Access Compliance Report

Public Rights-of-Way

(Curb Ramps)

Intersection ID: 13224	Main Street: BARRINGER_DR	Cross Street: BETHEL_RD	Location: W
ADA ID: D937B67B070C	Ramp Type: BlendTrans2	Initial Pass/Fail: Fail	Overall Compliance: No
			Severity Score: 33.75

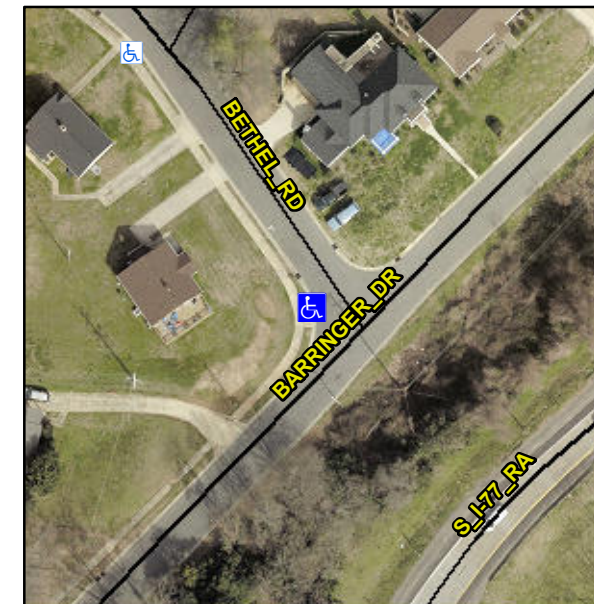
Not Found, R304.5.1, R304.5.3

Compliance	Description	Data	Compliance	Description	Data
N/A	Ramp Length (in)	107.0	Yes	BlendTrans Slope (%)	4.6
No	Ramp Width (in)	37.0	No	BlendTrans XSlope (%)	10.7
N/A	Flare Type LT	N/A	N/A	Flare Type RT	N/A
N/A	Flare Slope LT (%)	N/A	N/A	Flare Slope RT (%)	N/A
N/A	Flare Traversable LT?	N/A	N/A	Flare Traversable RT?	N/A
N/A	Landing Length (in)	N/A	N/A	DWS Provided?	N/A
N/A	Landing Width (in)	N/A	N/A	DWS Contrast?	N/A
N/A	Landing Slope (%)	N/A	N/A	DWS Length (in)	N/A
N/A	Landing X Slope (%)	N/A	N/A	DWS Full Width?	N/A
N/A	Landing Curb? (Y/N)	N/A	N/A	DWS Offset (in)	N/A
N/A	Shared Landing?	N/A			
N/A	Gutter Ponding?	N/A	N/A	Gutter Slope (%)	N/A
N/A	Gutter Lip Ht (in)	N/A	N/A	Gutter X Slope (%)	N/A
N/A	Painted X Walk1?	No	N/A	Painted X Walk2?	No
	X Walk 1 Direction	To SE		X Walk 2 Direction	To NE
	X Walk 1 Width (in)	N/A		X Walk 2 Width (in)	N/A
	X Walk 1 Slope (%)	6.0		X Walk 2 Slope (%)	2.2
	X Walk 1 X Slope (%)	2.5		X Walk 2 X Slope (%)	7.1

N/A	Ramp inside XWalk1?	N/A	N/A	Ramp inside XWalk2?	N/A
	Road Slope (%)	8.1		Clear Space?	N/A
	Road X Slope (%)	0.5	N/A	Clear Space to XWalk (in)	N/A
N/A	Any Obstructions?	N/A	N/A	Storm Grate/Utility Hazard?	N/A
	Obstruction Type			Storm Grate/Utility Type	
		N/A			N/A
			Yes	Surface Condition? (G/P)	Good
			No	Curb Slope (%)	10.5

Remove & Replace Curb Ramp With Two New Directional Ramps or Equivalent.
